AMT LPCA vertical sensor

AMT12 Open Stride units

Figure 1: Vertical sensor

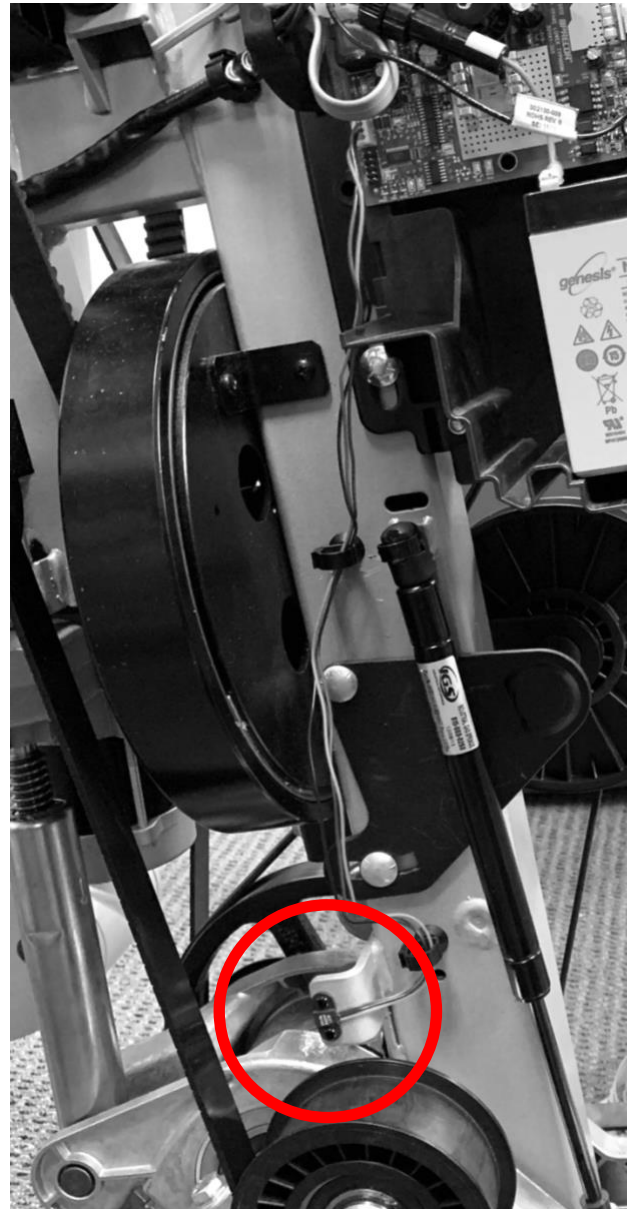
If there is an issue with the vertical stride sensor (see Figure 1), Error 62 will be displayed. The most likely cause of this will be a faulty, broken, or poor cable connection at the lower PCA. A missing or reversed magnet on the crank arm is also a possibility, as is a defective sensor. Least likely but possible is a fault on the lower PCA.

Technicians need to be aware of the following circumstances when working on AMT LPCA's and the vertical sensor, as this feature has been removed from current production:

- On AMT12 Open Stride units **after 6/3/2019**:
The LPCA has been redesigned and the vertical sensor connector has been removed. A jumper is not used.

- On AMT12 Open Stride units **prior to 10/18/2018**:
If Error 62 is displayed and the vertical sensor is the problem, the vertical sensor should be unplugged and removed. Next, a jumper will need to be placed across pins 2 and 3 of the J8 connector, which will stop the reporting of the error.

Note: If LPCA 301444-107 is replaced for a different reason, install LPCA PN:305476-103 and remove the vertical sensor assembly (no jumper will be required, the vertical sensor circuit has been removed from LPCA PN:305476-103)

Figure 3: Vertical sensor jumper installed (pin 1, bottom, is left open)

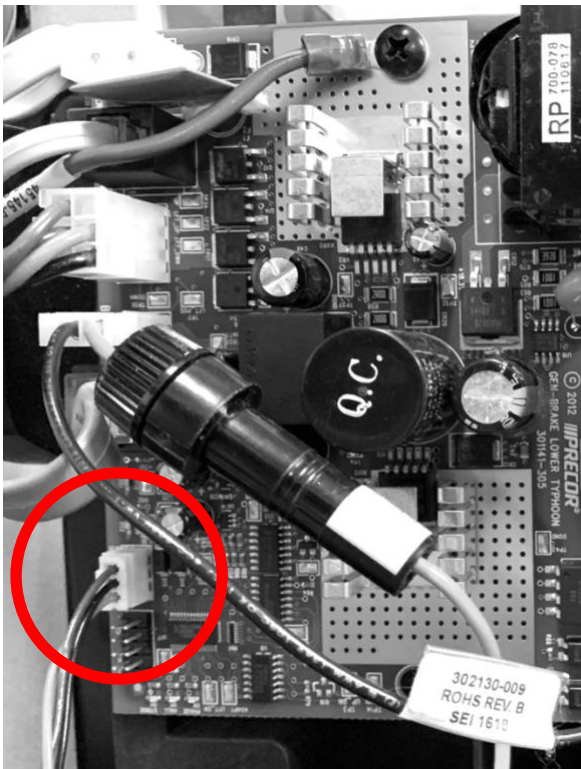
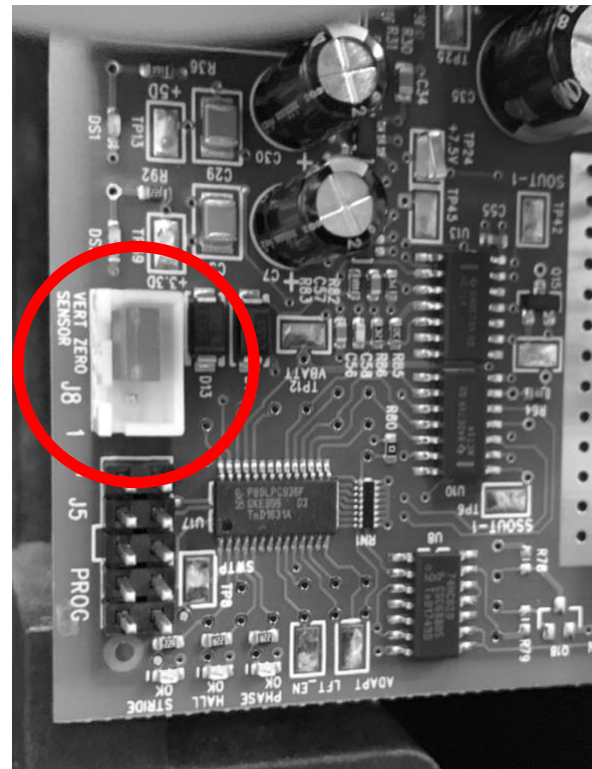
- 1 Access the LPCA (see service manual for procedure).
- 2 If Error 62 is displayed, determine if the problem is the sensor or the LPCA. See the [Error Code Troubleshooting Guide](#) for procedure.
 - a. If the problem is the sensor, unplug and remove the sensor and install the Vertical Sensor Jumper across pins 2 and 3 (**top two pins** – the bottom pin is pin 1) of the J8 connector. See Figures 2 and 3.
 - b. If the problem is the LPCA, replace with LPCA PN: 305476-103 and remove the vertical sensor.
- 3 Verify operation and return to service.
